May 3, 2016

SUBJECT: PIER 4 PHASE 2 RECONFIGURATION
PROJECT NO. 091251
CONTRACT NO. 070136

ADDENDUM NUMBER THREE

**ELEVATION-CRANE STOPS
LANDSIDE AND WATERSIDE**

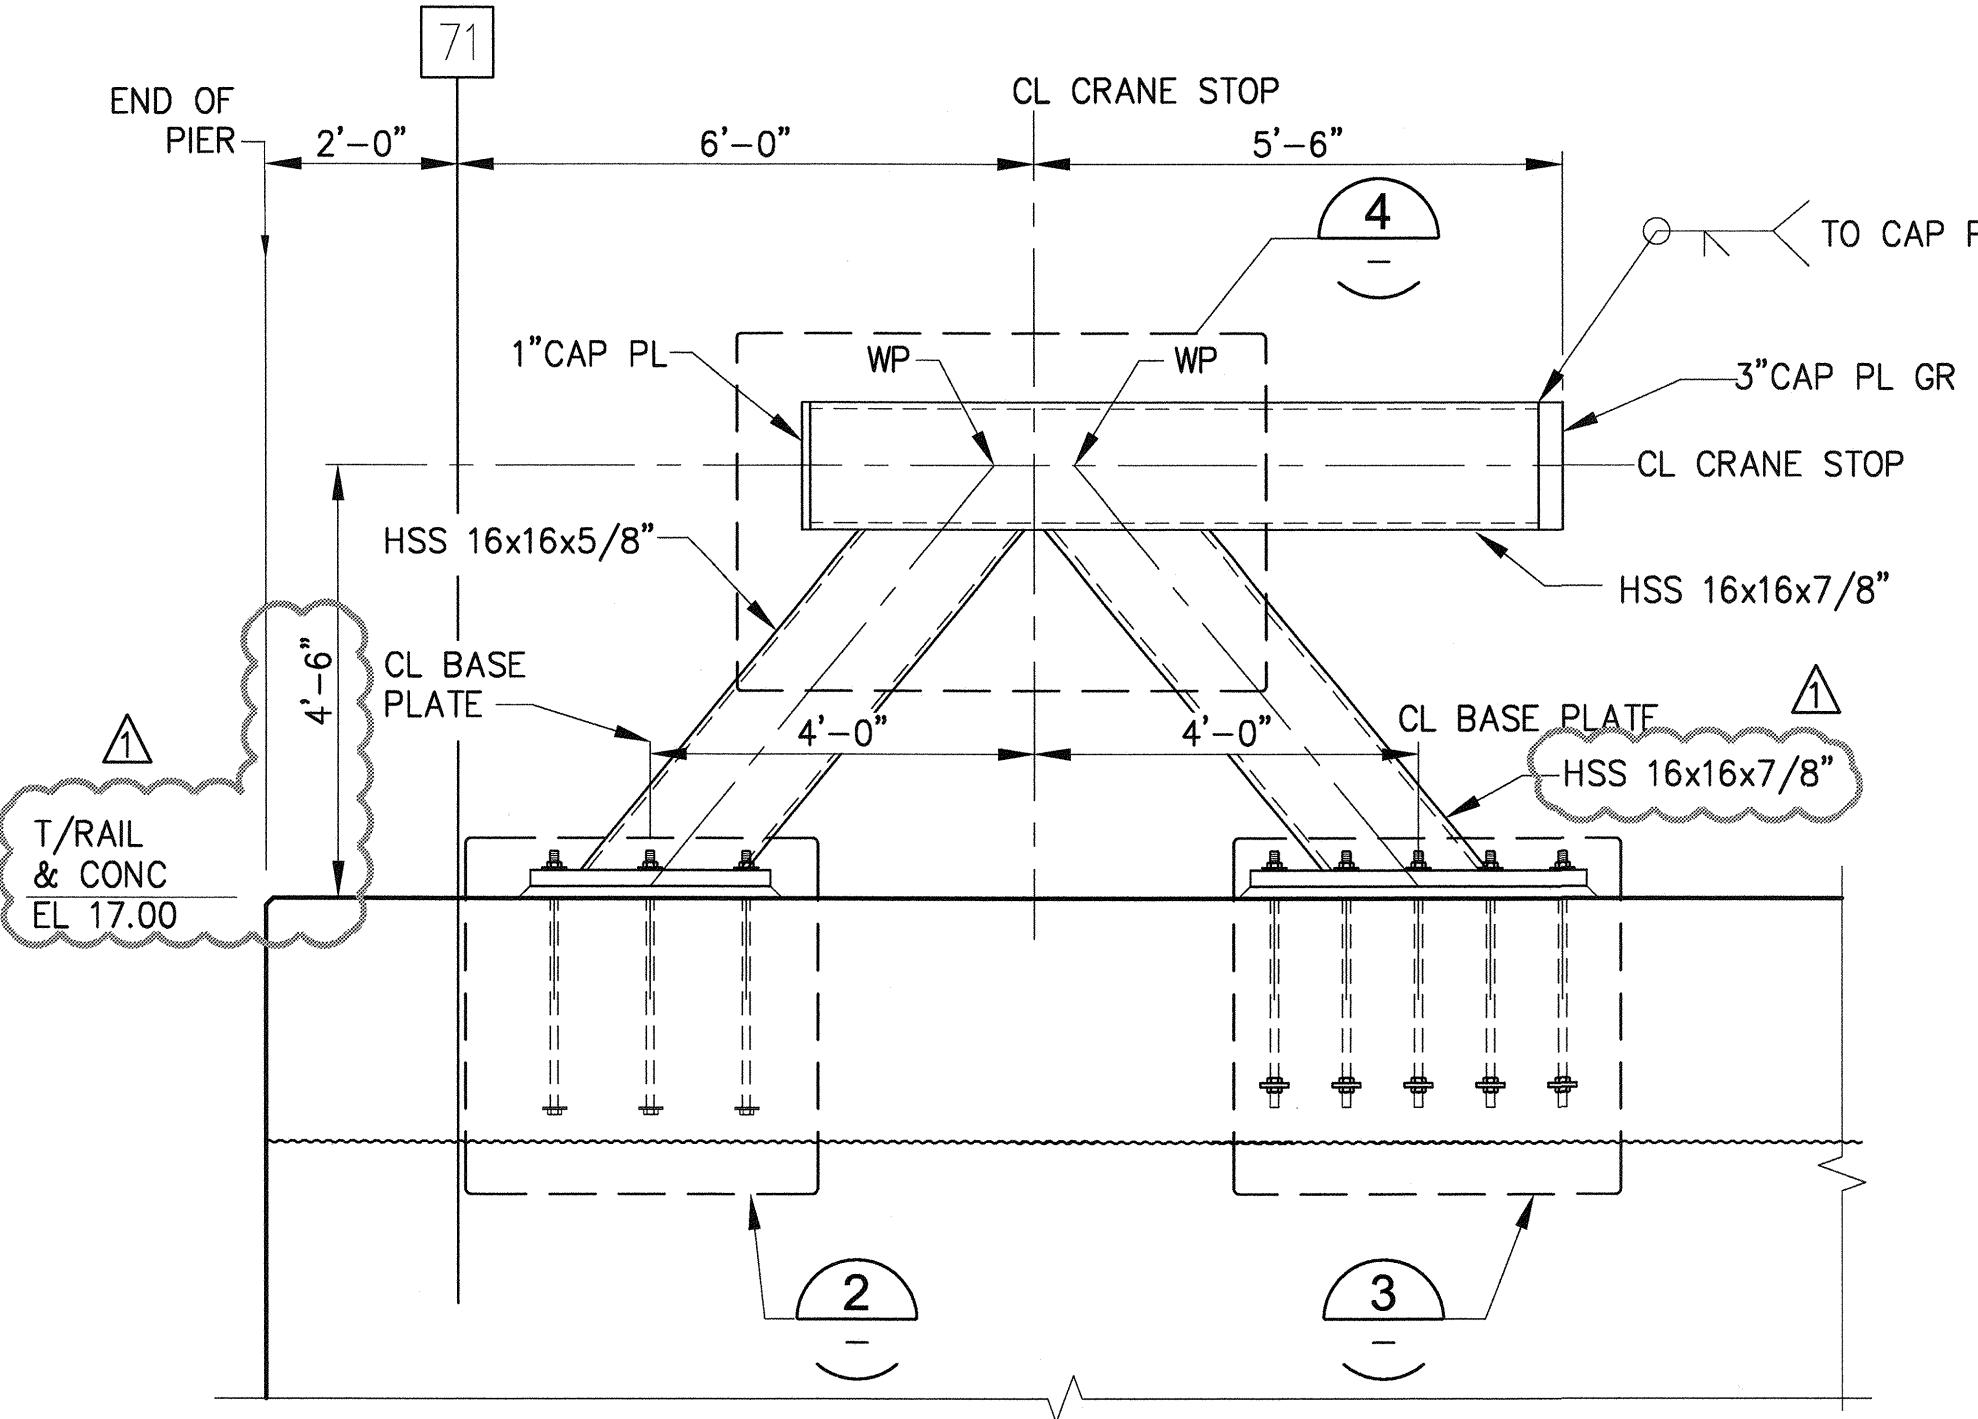
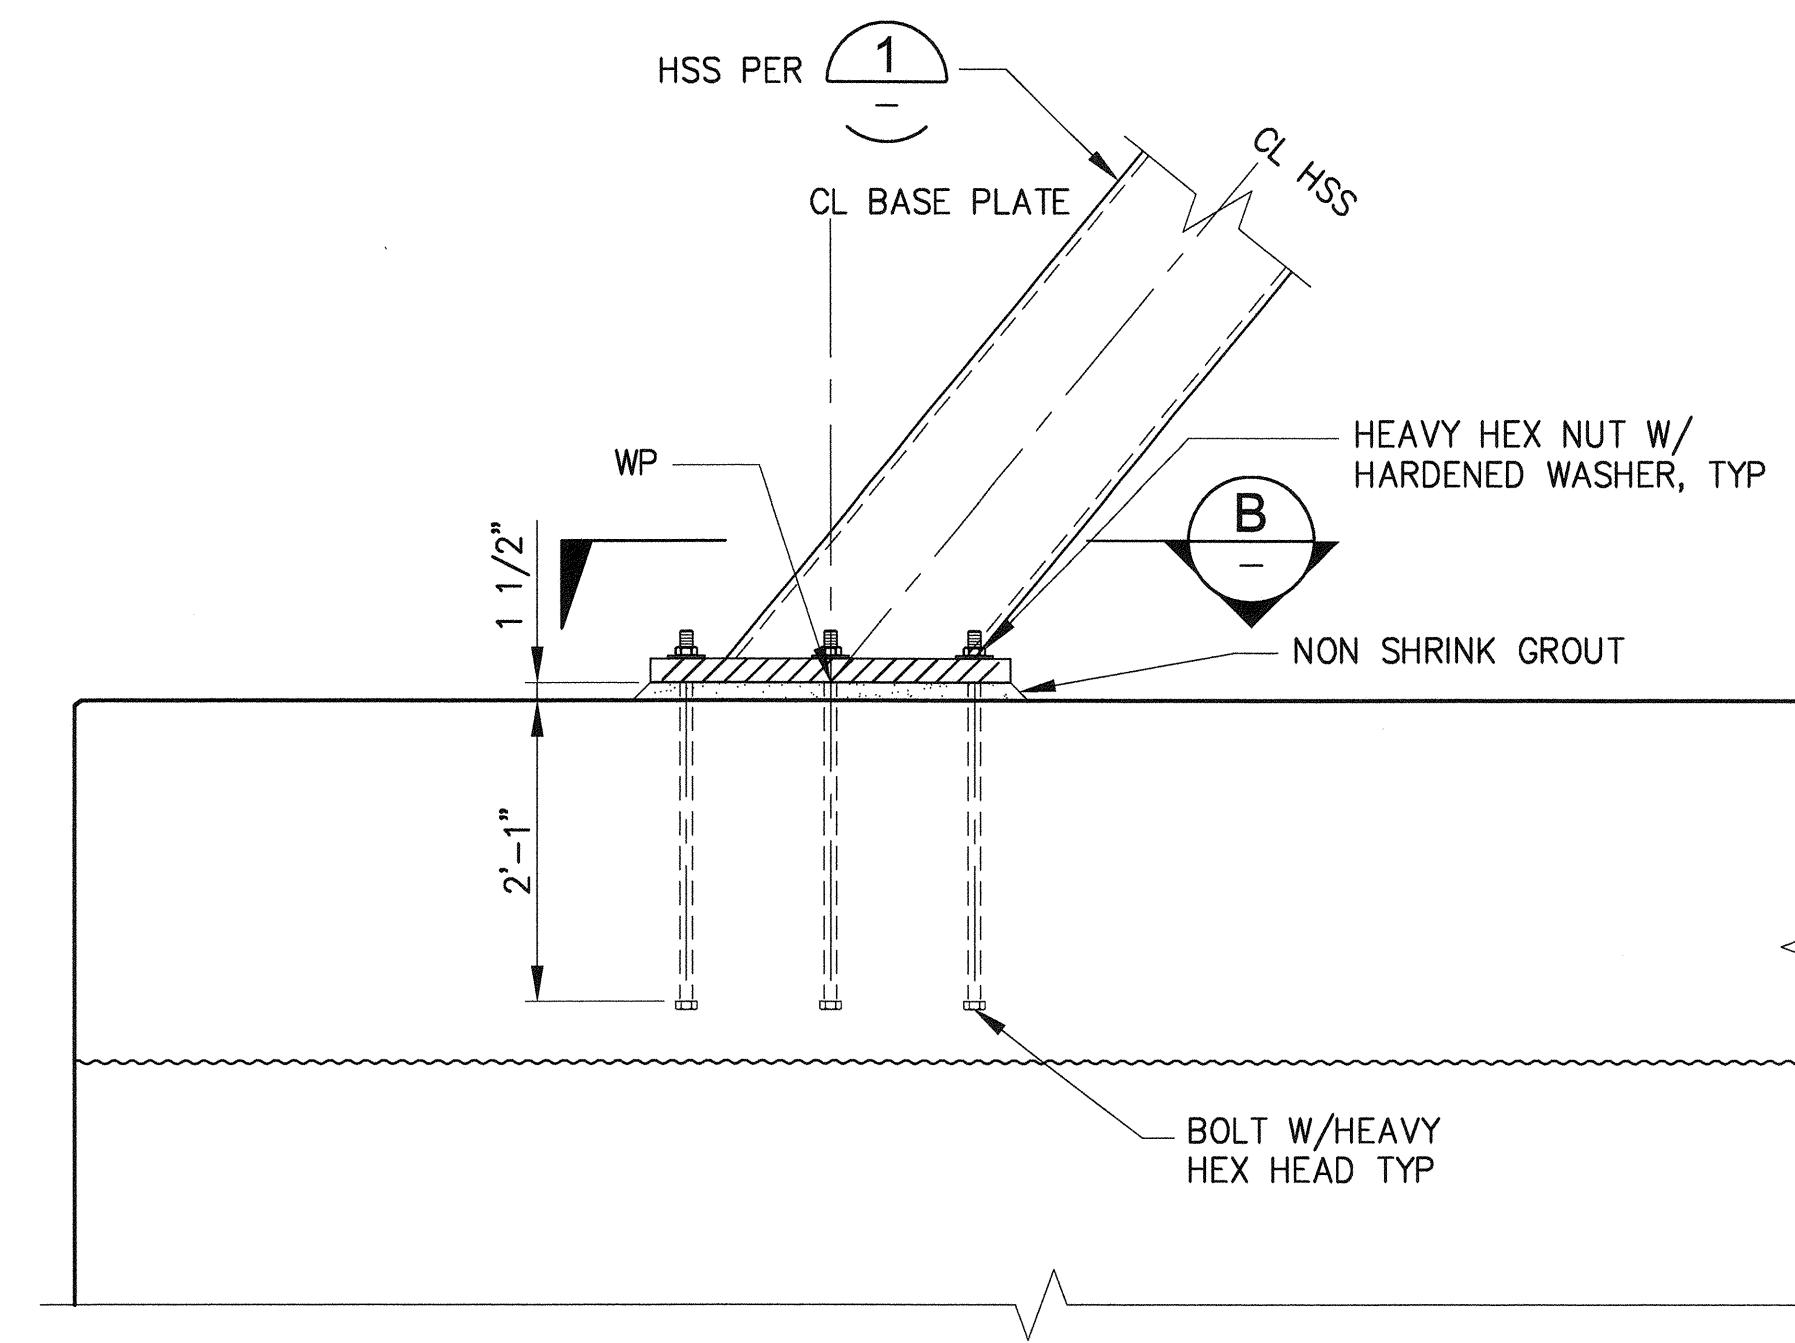
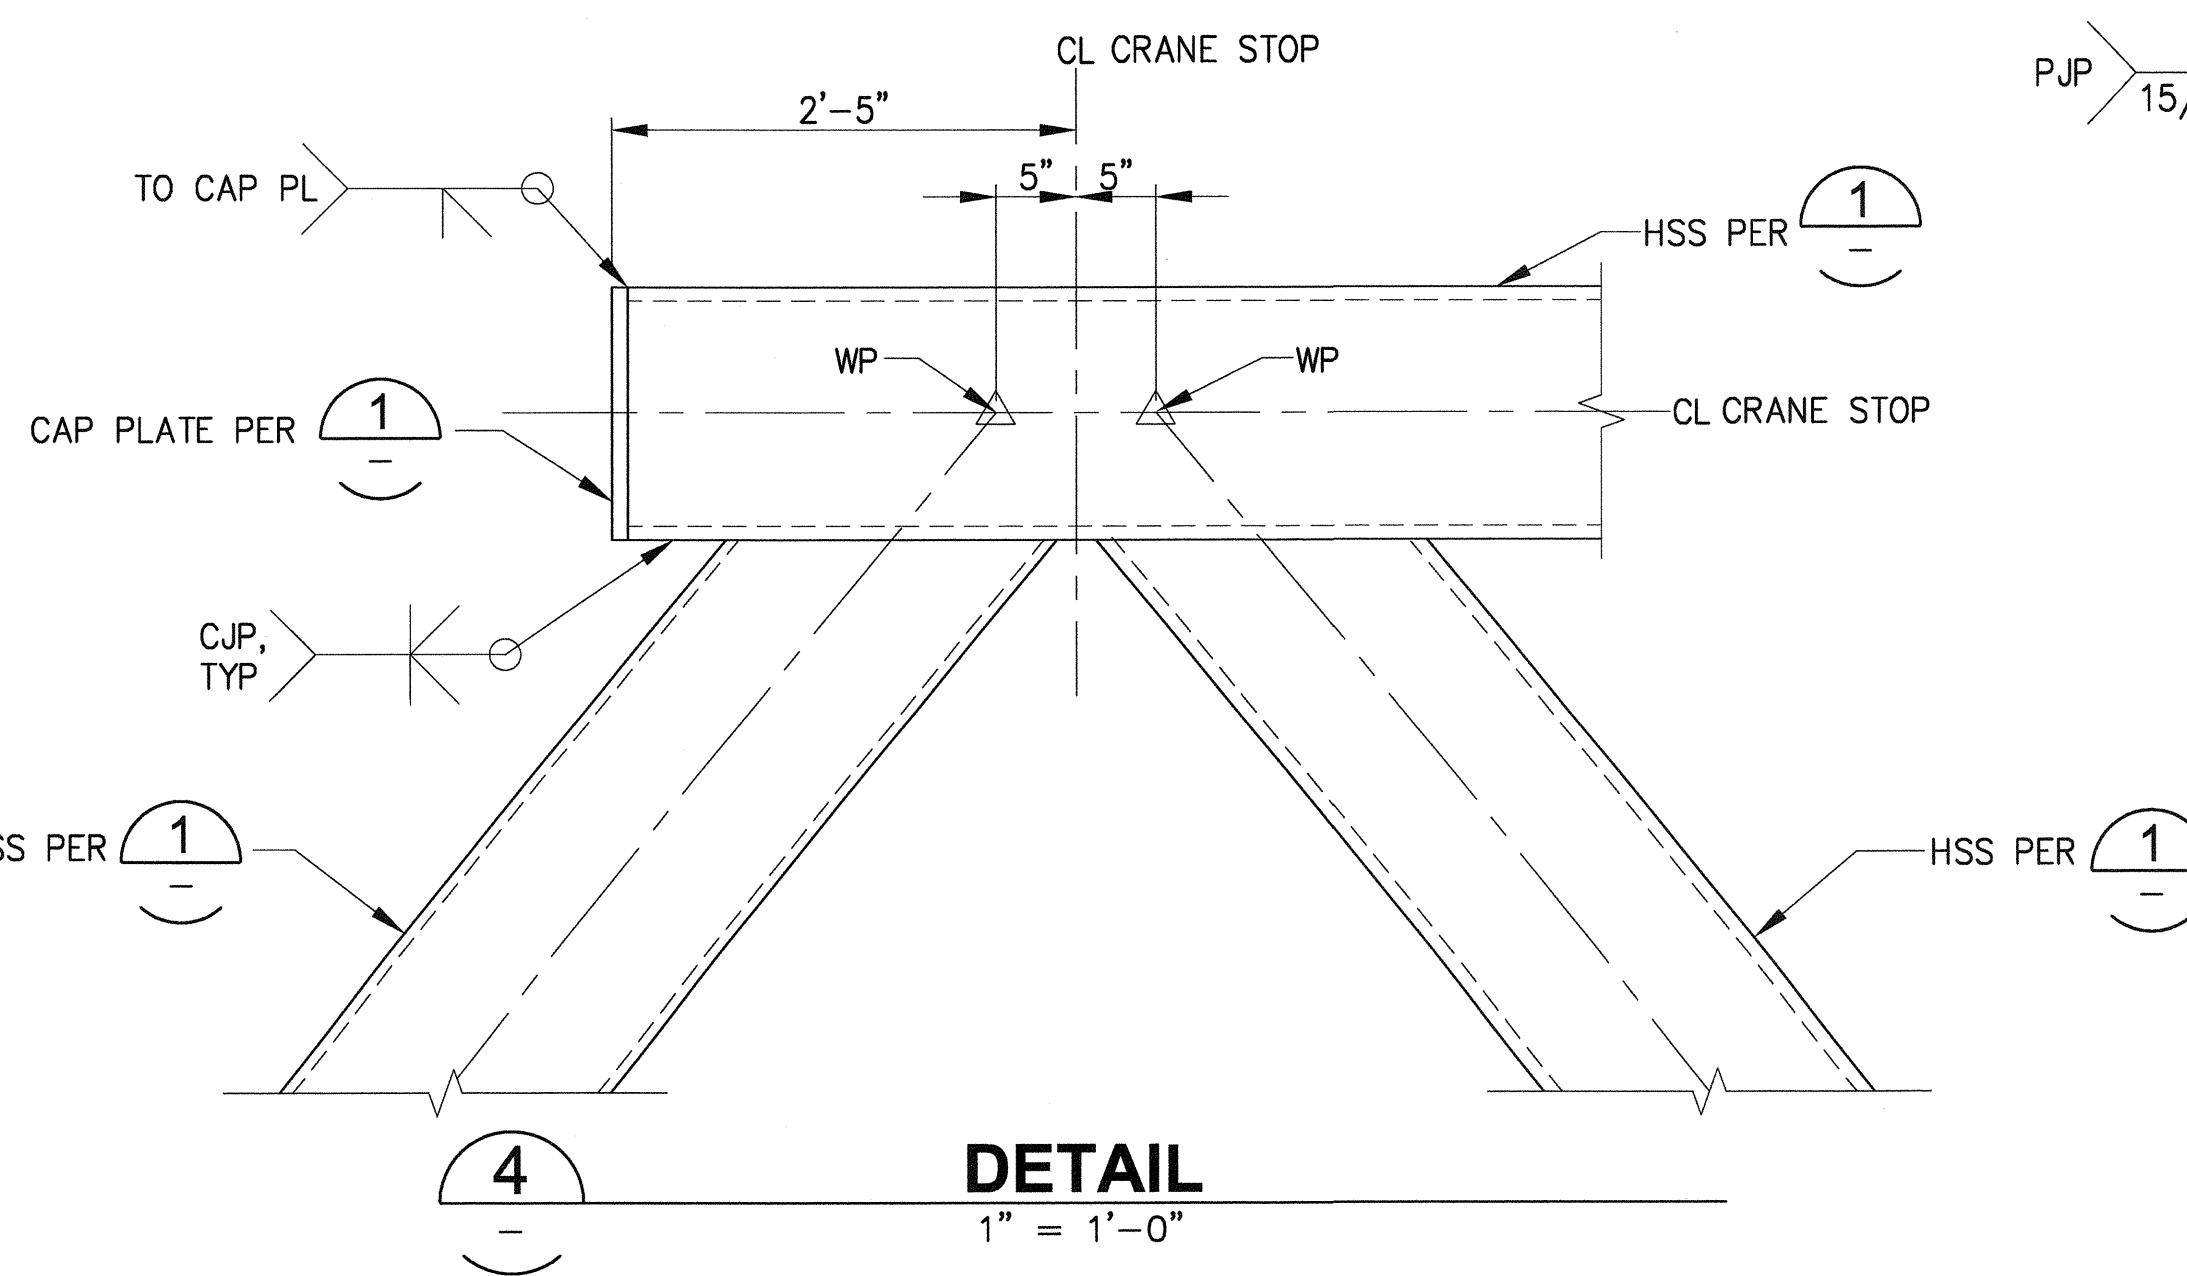
I. DRAWING S36.1 CRANE STOP DETAILS (SHEET 369)

1. **REVISE** height of crane stop, as denoted in Detail 1 Elevation –Crane Stops Landside and Waterside; anchoring, as denoted in Detail 3 Detail – Crane Stop Base Plate Anchoring – Front Post; and welds, as denoted in Detail A Section – Crane Stop Base Plate – Front Post. (See Attachment J to this Addendum No. 3)
